# Technical Service Bulletin

**01 MIL on, DTCs P218100, P017B00, P308100, and/or P01E400 are stored in the ECM**

01 20 82 2058767/6 August 26, 2020. Supersedes Technical Service Bulletin Group 01 number 20-65 dated June 8, 2020 for reasons listed below.

*Figure 1. Gap between chamber and seal.*

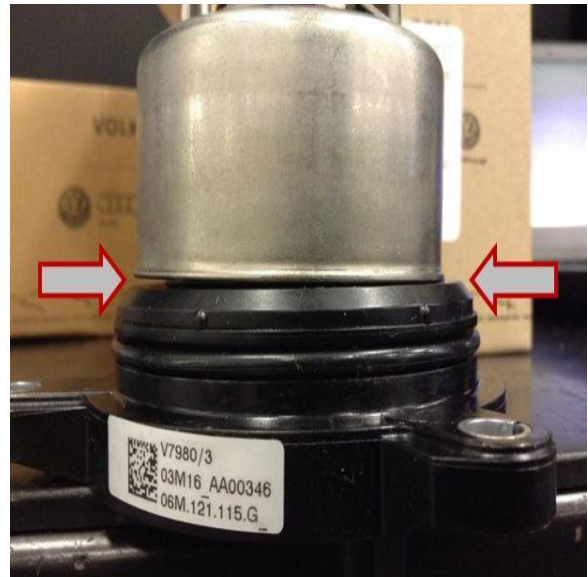
1. Remove the thermostat and check whether it closes completely. If the coolant is still warm, put the thermostat in cold water to restore its original condition. If there is a gap between chamber and seal, the thermostat is faulty and needs to be replaced.
2. Attach photos to the repair order which clearly shows that the thermostat does not close neatly.

After the repair, fill with G12evo coolant in the coolant circuit.
